RESPONSE TO OFFICE ACTION
Attorney Docket No. 11009-22
Page 11 of 17

U.S. Patent Application No. 10/630,342

Attorney: John V. Daniluck/ Docket 11009-22

Fig. 2
(Prior Art)

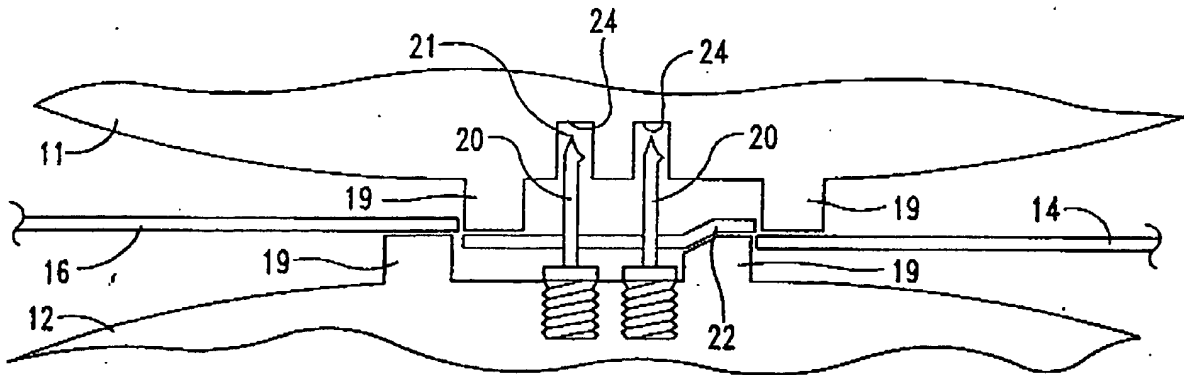
FIGS. 1-5 were objected to for not including a legend such as "Prior Art." Further, FIG. 8 was objected to for an arrow that is in the wrong direction.

Applicant has corrected these errors and provided replacement sheets with this Response. Applicant requests withdrawal of the objection.
